Land East of Hawksworth and North-West of Thoroton Landscape Review

Prepared for: Rushcliffe Borough Council

Application Reference: 22/02241/FUL

Photo A – View from the public bridleway in Field 5, looking south towards Thoroton

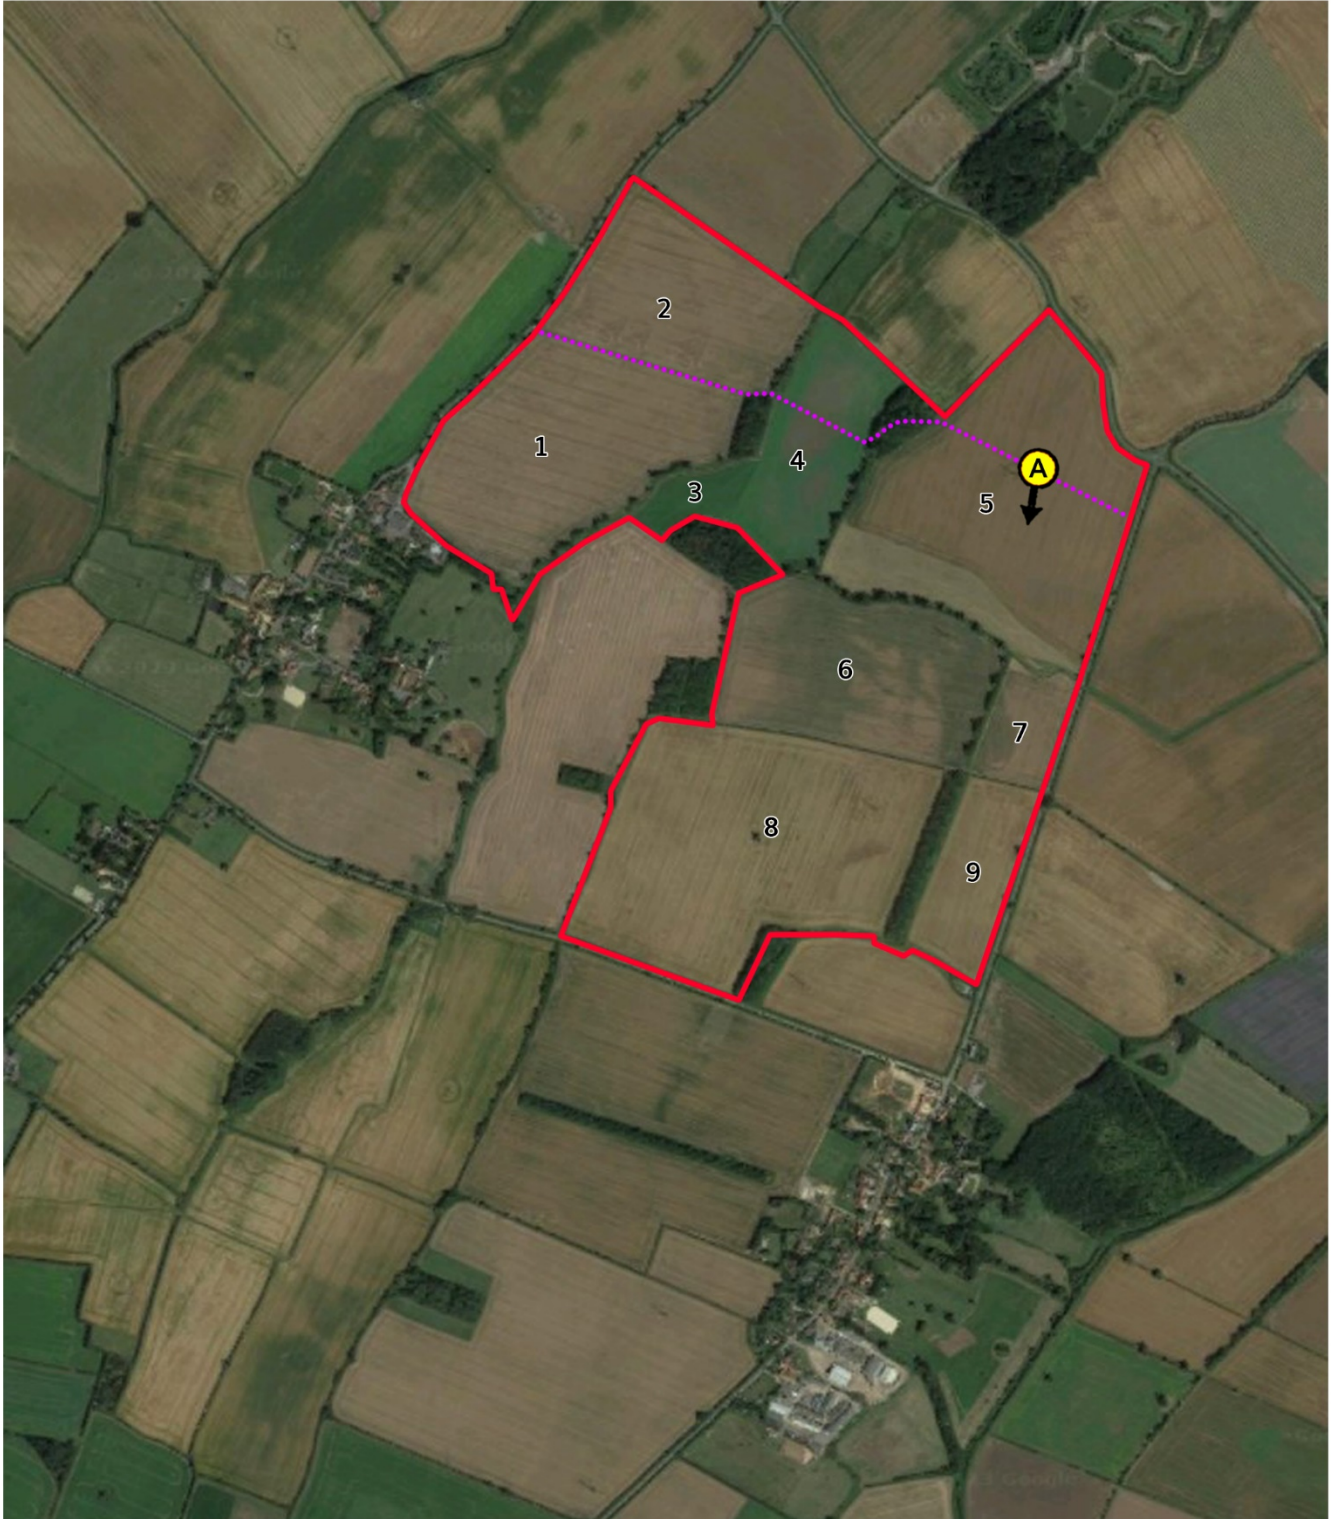
- Viewpoint 6 – agreed. However, there are sections along the bridleway within Field 5 where people will experience a higher level of visual effect due to the closer adjacency to mitigation planting [refer to my

Viewpoint A in Appendix B]. Proposed woodland mitigation planting will also restrict views to Thoroton and specifically the spire of St Helena's Church from parts of the PRoW. This is correctly identified as a sensitive view within the LVA.
